Service Bulletin

Date: 04 April 2011
Subject: Recall 2764 **Support kit for rear subframe**
Model: **F4 1000 MY 2010**

ASSEMBLY INSTRUCTION – REAR SUBFRAME SUPPORT KIT (PART NO. 8000B5361)

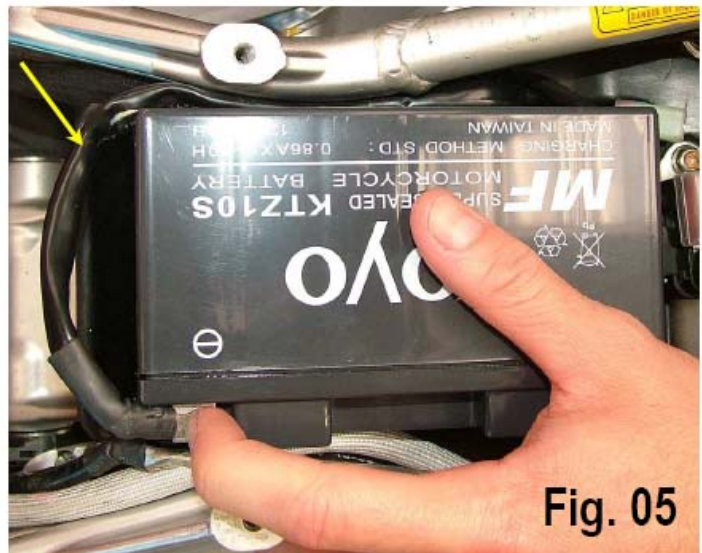
- Remove respectively the following components as described in the F4 Motorcycle Workshop Manual (P/N 8000B3601): Passenger saddle – Rider saddle – RH/LH fuel tank side panels – RH/LH Tail piece side fairings – Fuel tank – Fuel tank fixing support – RH/LH Passenger footrests supports – Battery.
Additionally, remove definitively the L62 rubber clamp you can possibly find in the area highlighted in Fig. 01.
After the preliminary disassembling operations have been performed, the rear subframe area must look as shown in Fig. 01.

- Remove the fixing screws of the holding plate for the lock transmission and place the plate on the outer side of the rear subframe (see Fig. 02-03).

- Apply the protection P/N 8000B4922 on the side of the battery as shown in Fig. 04.
- Reassemble the battery on the motorcycle by placing the negative terminal cable as shown in Fig. 05.

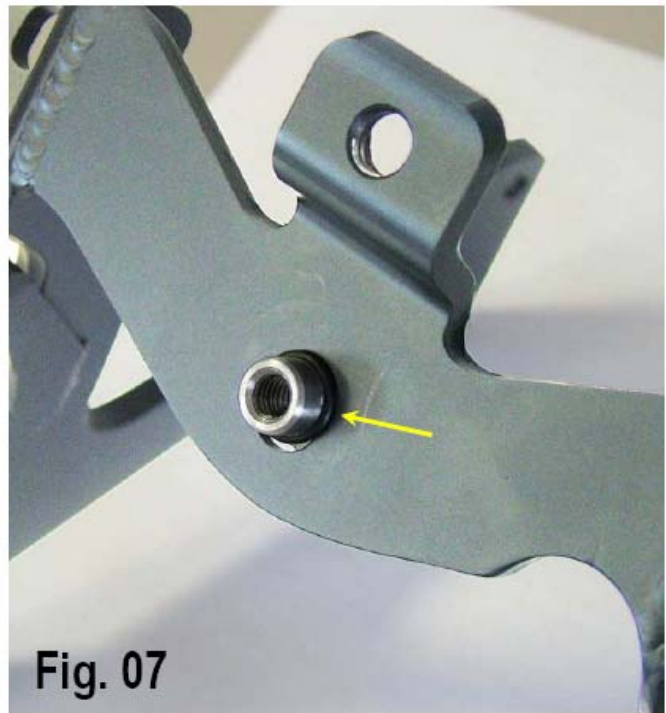
- Take the support from the new rear subframe support kit (P/N 8000B5361) and insert the special nut (P/N 8000B5360) in the central hole as shown in Fig. 06.
- Insert the O-Ring (P/N 8000A2181) on the seat present on the special nut as shown in Fig. 07.

- Remove No. 2 well-nuts from the previously removed fuel tank fixing support, and insert them in the multiple support taken from the kit (see Fig. 08-09).

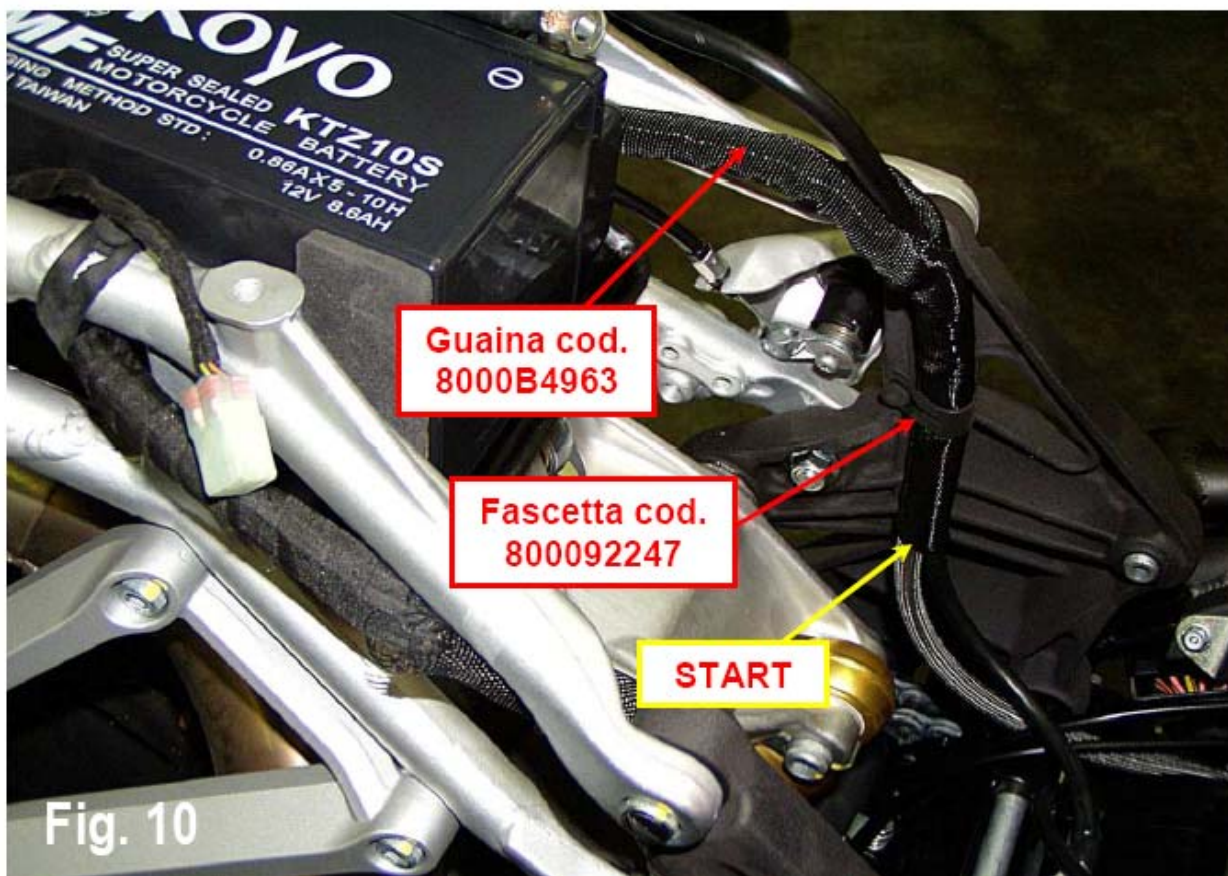
- Remove the clamp P/N 800092247 from LH side subframe plate. Insert the sheath P/N 8000B4963 on the wire harness by positioning it from the highlighted “START” point, then replace the clamp P/N 800092247 as shown in Fig. 10.

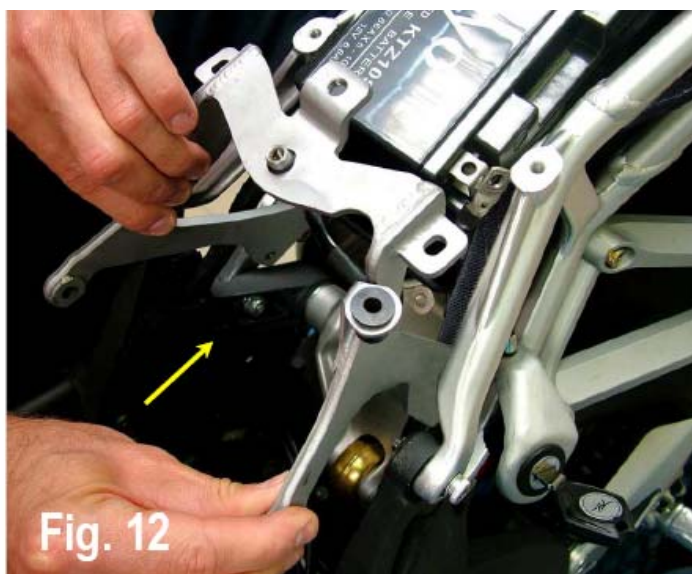
- Slightly loosen the upper screws fixing the rear subframe to the side subframe plates, in order to extract them as much as necessary in order to allow the following insertion of the multiple support (see Fig. 11).
- Place the multiple support on the rear subframe, making sure to correctly position the wire harness in order to avoid damaging it (see Fig. 12-13-14).

- Couple the lower fixing joints of the multiple support with the upper screws fixing the rear subframe to the side subframe plates (see Fig. 15-16).
- Insert the upper screws for rear subframe/side plates fixing in the fixing joints of the multiple support (without re-using the previously removed nuts), and tighten them at a torque of **24 Nm** (see Fig. 17).

Fig. 21

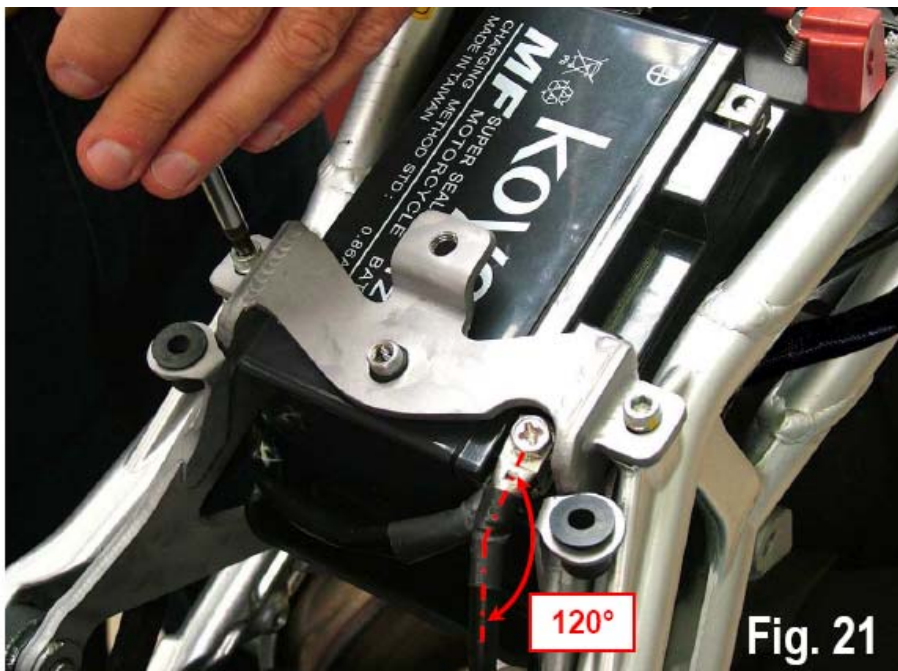
- Reassemble the holding plate for the lock transmission on the rear subframe, by placing the lock transmission on the internal side of the rear subframe as shown in Fig. 18.
- Reassemble the positive cable terminal on the battery according to the previous layout (see Fig. 19).
- Reassemble the no. 2 negative cables terminals on the battery according to the new layout shown in Fig. 20.

- Bend the negative cable at 120° with reference to its terminal according to the layout shown in Fig. 21.
- Insert and tighten the No. 2 M6x18 screws (P/N 8F0085071) fixing the multiple support to the rear subframe (see Fig. 21).

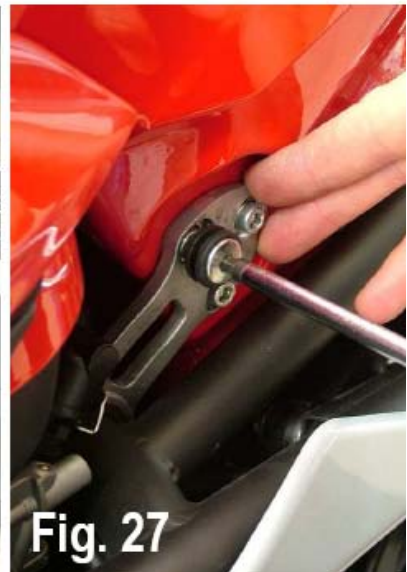
- Take the No. 2 RH/LH lower brackets from the kit and fix them on the lower part of the multiple support by inserting No. 4 M6 screws (P/N 8A00B2681) as shown in Fig. 22-23.
- Reassemble the RH/LH passenger footrest supports by inserting No. 4 M8x30 screws (P/N 8D00B2690 – Fig. 24).

- Reassemble the previously removed components by reversely performing the assembling operations. Before reassembling the fuel tank, slightly slacken the RH/LH side brackets fixing screws (see Fig. 25).
- Reassemble the fuel tank on the motorcycle and fix it by inserting the previously removed screw (Fig. 26).
- Tighten the RH/LH side brackets fixing screws by keeping the brackets in contact with the subframe tube (Fig. 27).
